# Car Stereo Service Bulletin

**Model:** MDX-40/400

**No.** 360

**Subject:** Audio Skipping

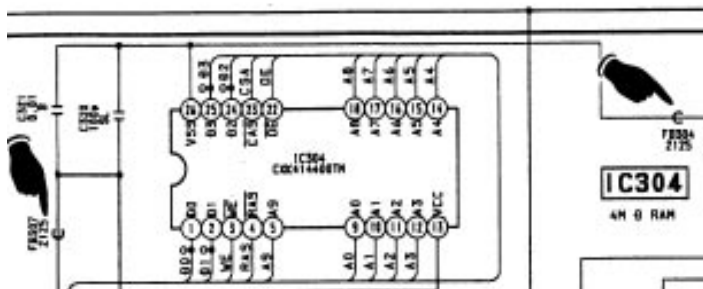
(57) The audio skips when playing pre-recorded and recordable discs.

In some cases, this problem may be eliminated by replacing ferrite bead inductors FB304 and FB307 with 0 ohm jumper resistors. If installing the jumper resistors fails to correct the problem, conventional troubleshooting techniques should be used.

REF	FORMER		NEW	
	DESCRIPTION	PART NUMBER	DESCRIPTION	PART NUMBER
FB304 FB307	INDUCTOR, FERRITE BEAD	1-414-235-11	RESISTOR, 0 OHM	1-216-295-11
